APPLICATION TO THE RESIDENTIAL DESIGN AND COMPATIBILITY COMMISSION (RDCC)

GENERAL MODIFICATION WAIVER

Master Comment Report

Date: Contents: October 16, 2014 Comment Responses

A101

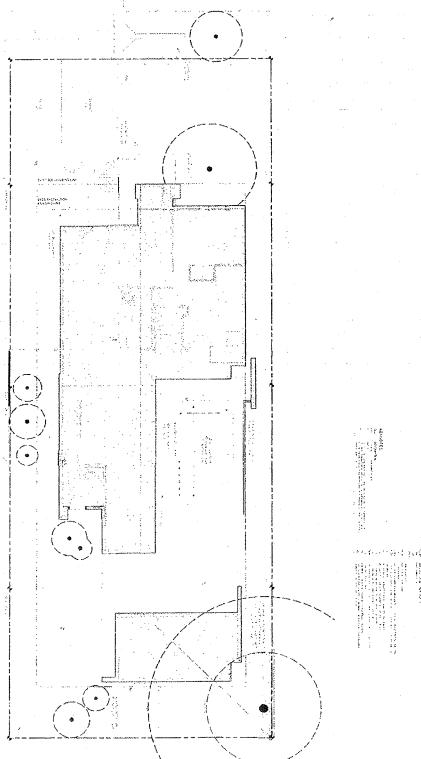
- 6. Sheet A101
 - a. 4'-0" sidewalk to be shown.
 - b. License agreement to be established for the steel planter in the ROW. Please contact Andy Halm at (512) 974-7185 or andy.halm@austintexas.gov

- a. Approval of Fee in Lieu Sidewalk Payment signed on June 20, 2014 and paid in full on June 27, 2014.
 - b. Existing steel planter to be removed. Noted as such on drawings.

- c. Temporary benchmark established on site plan.
 - d. Dashed lines removed since not significant.
 - e. Northwestern curb existing curb, Northeastern curb revised.

A201

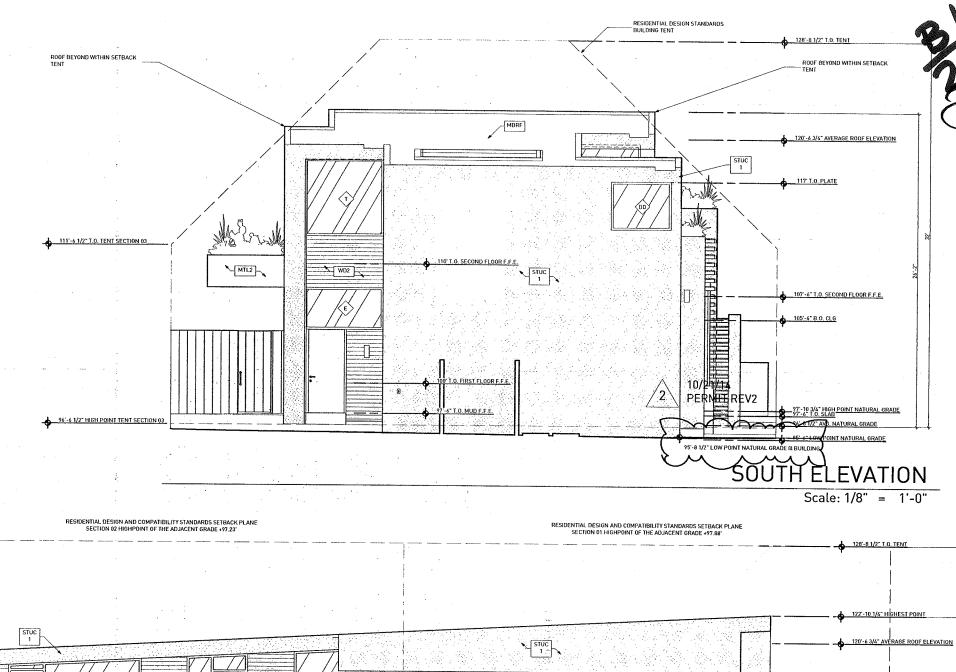
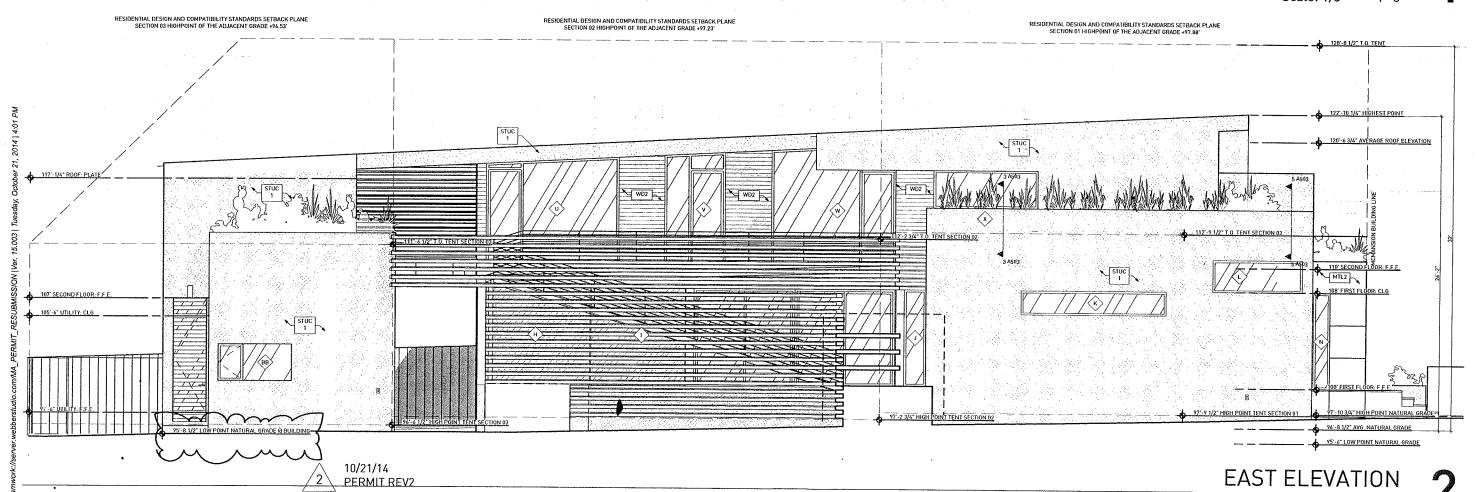
- 9. Sheet 201
 - a. Subchapter F compliance could not be confirmed since spot elevation information was not provided on sheet A101.

- b. 1/201: NW protrusion Historically, a shed roof has been defined as having a slope of 3:12 or greater. If slope is less than 3:12, it is considered a flat roof and is not allowed to protrude from the tent. Discrepancy to be resolved.
- c. 1/201: architect to confirm that top plate of NW corner of the residence does not protrude out of the tent. If it does, top plate elevation to be revised so that it does not.
- d. 1/201: Section 2.6.D. of subchapter F does not apply per section 2.6.d.3.b. Discrepancy to be resolved.
- e. 1/201: NE corner protrusion does not qualify for the shed roof exception since the roof at this location is a gable. Discrepancy to be resolved.

- a. Hot tub removed.
- b. See 7.a.
- 8. Roof pitches provided.
- 9. Sheet A201
 - a. Spot elevation provided.
 - b. 1/A201: Design revised. Roof now within Subchapter F McMansion tent.
 - c. 1/A201: Design revised. Roof now within Subchapter F McMansion tent.
 - d. 1/A201: Subchapter F McMansion tent revised.
 - e. 1/A201: Design revised. Roof now within Subchapter F McMansion tent.

A202

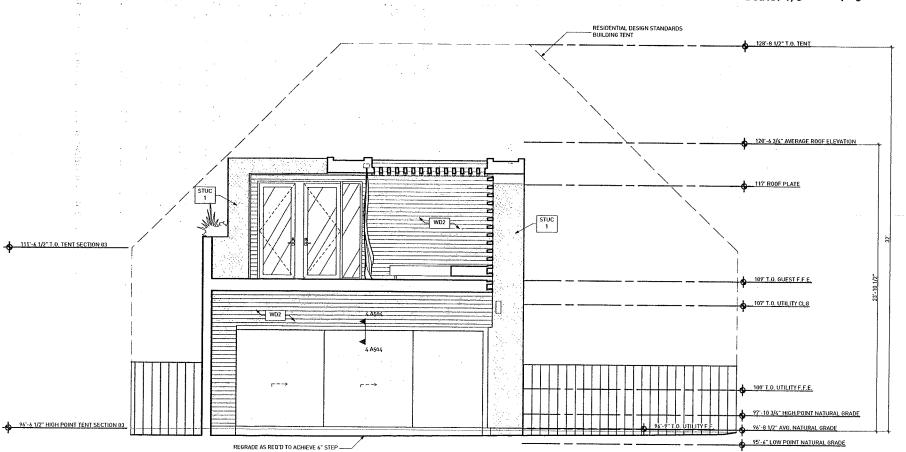
10. Sheet 202

- a. Subchapter F could not be confirmed since spot elevation information was not provided on sheet A101.
- b. 1/202: NW protrusion Historically, a shed roof has been defined as having a slope of 3:12 or greater. If slope is less than 3:12, it is considered a flat roof and is not allowed to protrude from the tent. Discrepancy to be resolved.

10. Sheet A202

- a. Spot elevation provided.
- b. 1/A202: Design revised. Roof now within Subchapter F McMansion tent.
- c. 1/A202: Design revised. Roof now within Subchapter F McMansion tent.
- d. 2/A202: Design revised. Roof now within Subchapter F McMansion tent.
- e. 2/A202: Design revised. Roof now within Subchapter F McMansion tent.
- f. 2/A202: Design revised. Roof now within Subchapter F McMansion tent.
- 11. 1/A203: Design revised. Roof now within Subchapter F McMansion tent.
- 12. Design revised. Plans match design approved by RDDC.
